RE: A.L.R.T. DEVELOPMENT IN BURNABY

TO: MUNICIPAL MANAGER 1981 DECEMBER 29  
FROM: DIRECTOR PLANNING & BUILDING INSPECTION PLANNING DEPARTMENT  
SUBJECT: A.L.R.T. DEVELOPMENT IN BURNABY

RE: A.L.R.T. ALIGNMENTS AND STATION LOCATIONS IN BURNABY

FIG. 5

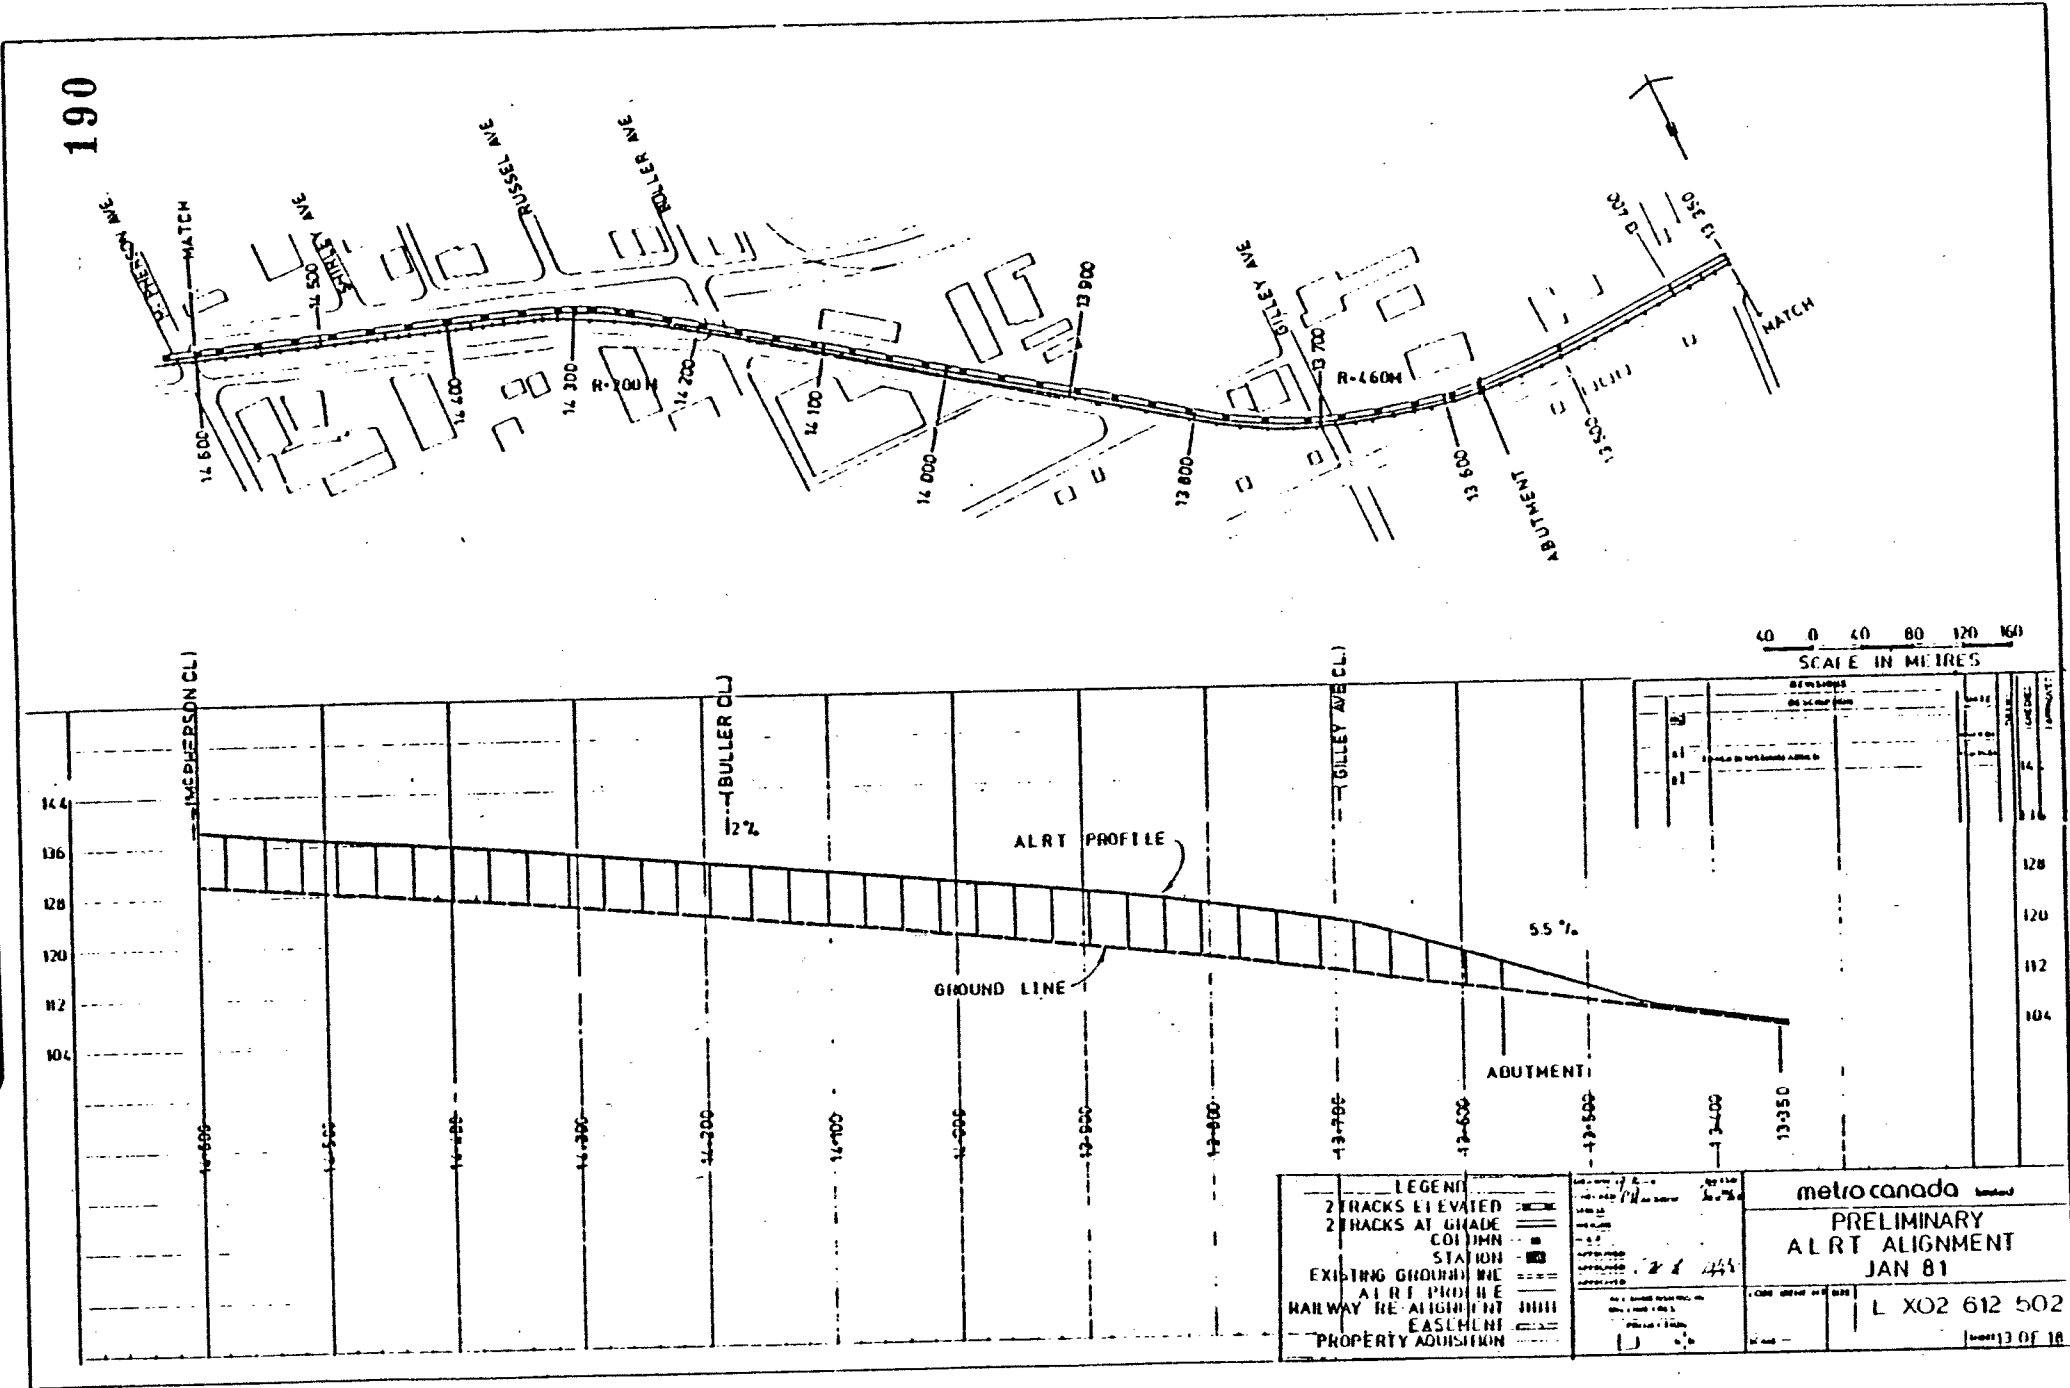
Specifically the U.T.A. staff have considered dropping A.L.R.T. to grade in the vicinity of Rumble (it is shown substantially elevated on the base line contract specification) which will create potential severance problems, reduce the accessibility of the Edmonds station to South Slope residents and close future options for land use development.

This station as shown in Fig. 5 is also being sited in general accordance with the endorsed LRT preliminary design concept. It is expected that a bus interchange will be developed adjacent to the station.

- 3.4 Consistent with 3.3 an elevated vertical alignment in the vicinity of Rumble and the Edmonds station should be adhered to and no further consideration given to at-grade operation of A.L.R.T.

FIG. 7

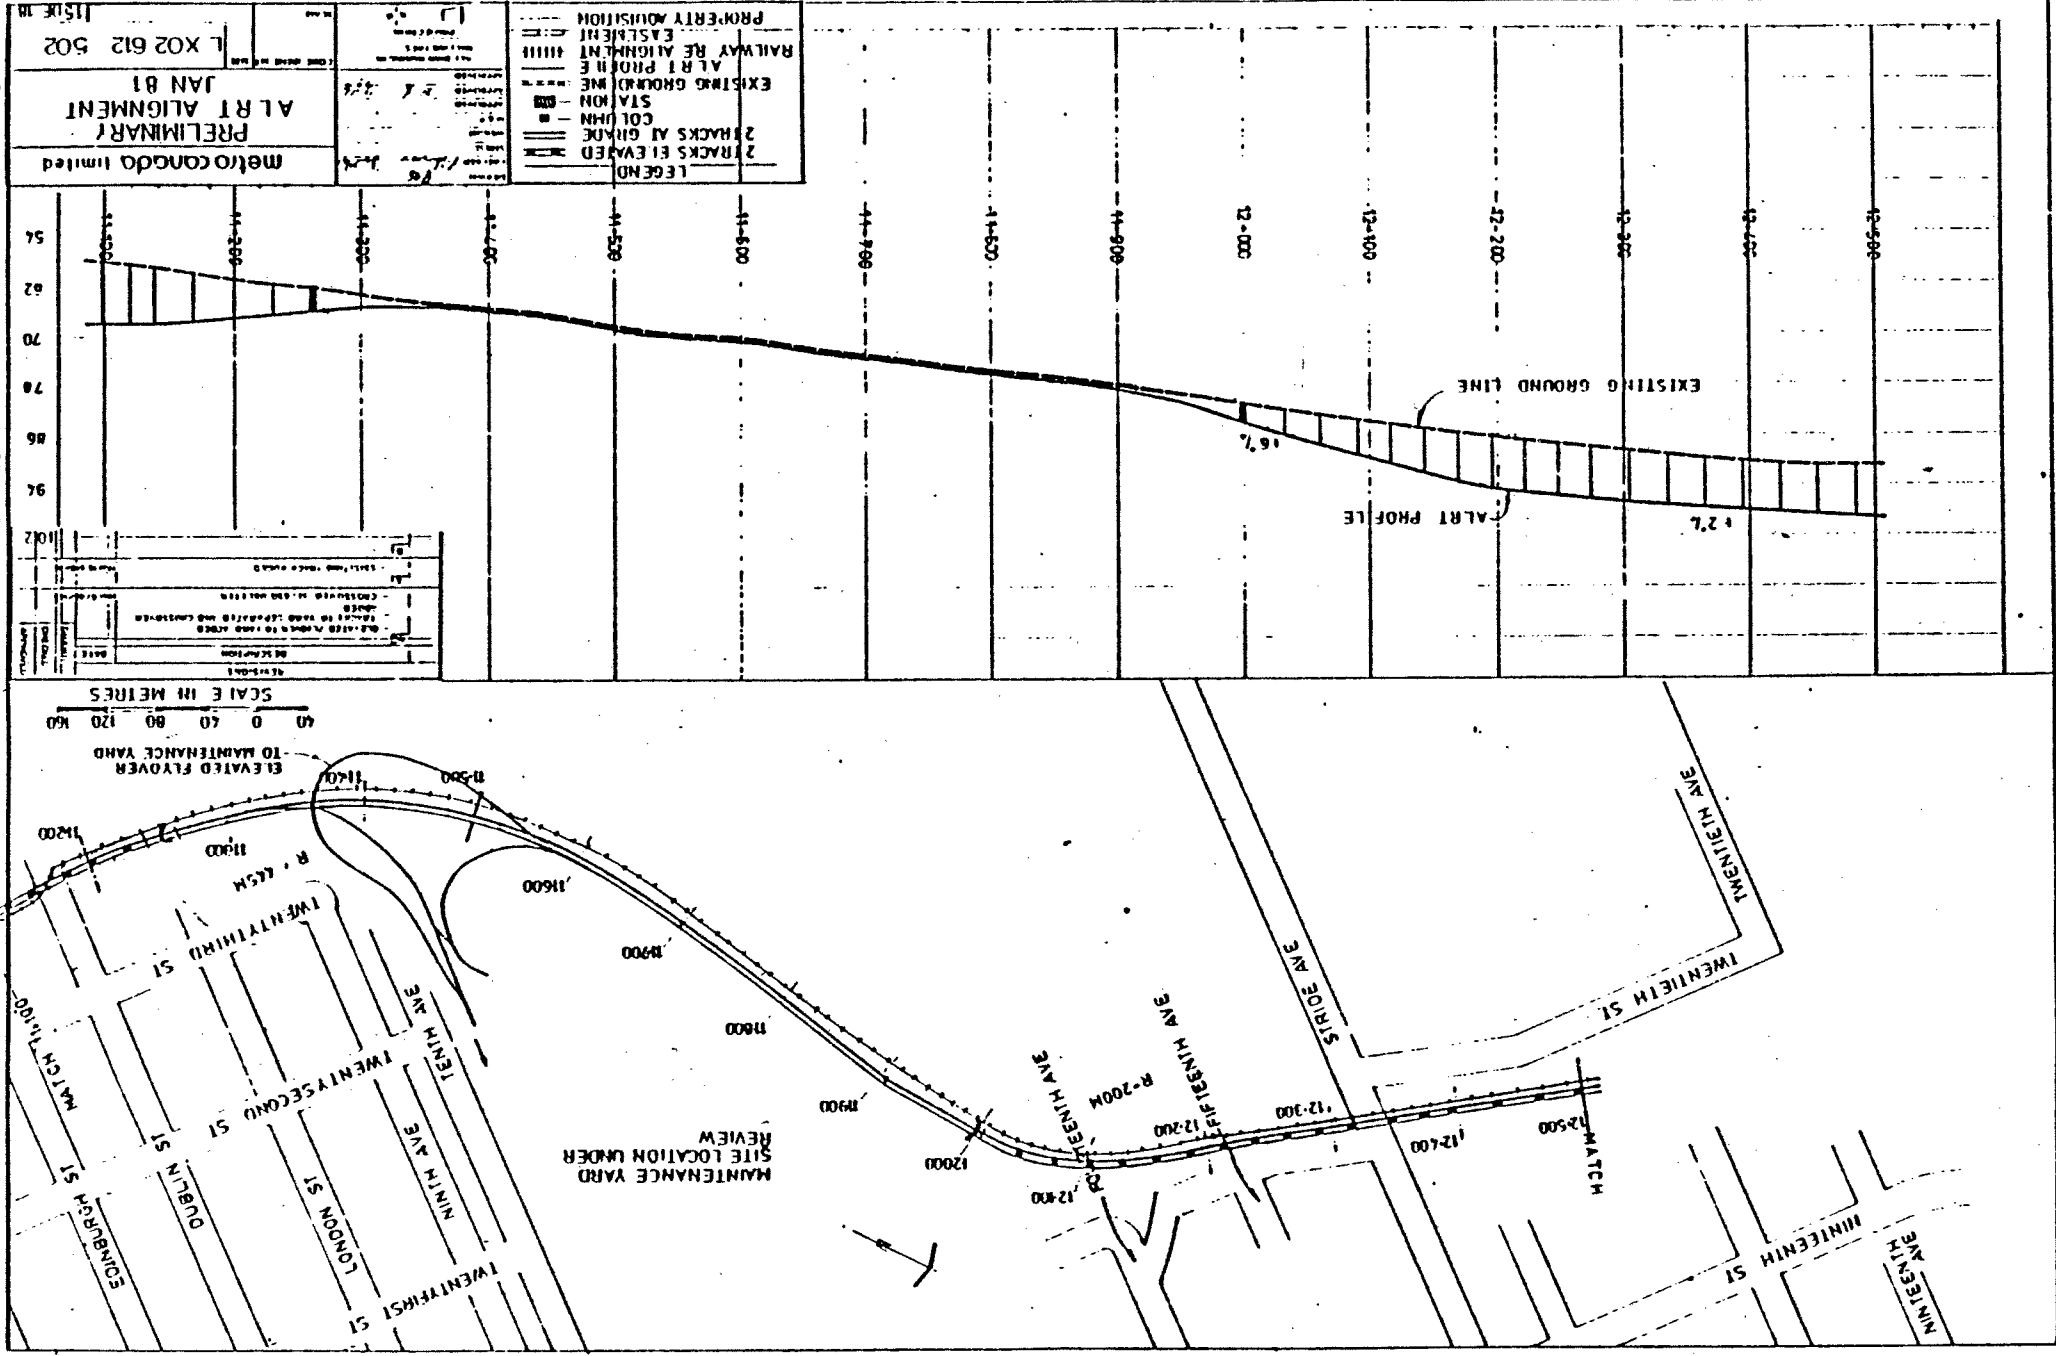
Planning staff have some concerns relative to locating a use such as an ALRT yard within the Municipality but it is generally agreed that the proposed site would be the best one. Obviously care will have to be taken and a close liaison maintained with municipal staff in order to minimize any adverse impact of such a facility. The layout of the ALRT yard site shown in Fig. 7 will need to be modified to accommodate the Marine Way-Tenth Avenue road proposal.

- 3.5 As previously agreed, the A.L.R.T. yard site should be located in the gravel pit area east of the B.C.Hydro rail right-of-way (in the area bounded by the rail right-of-way and the 10th Ave. and 20th Street rights-of-way). The A.L.R.T. yard layout should not preclude the development of a Marine Way/10th road link.
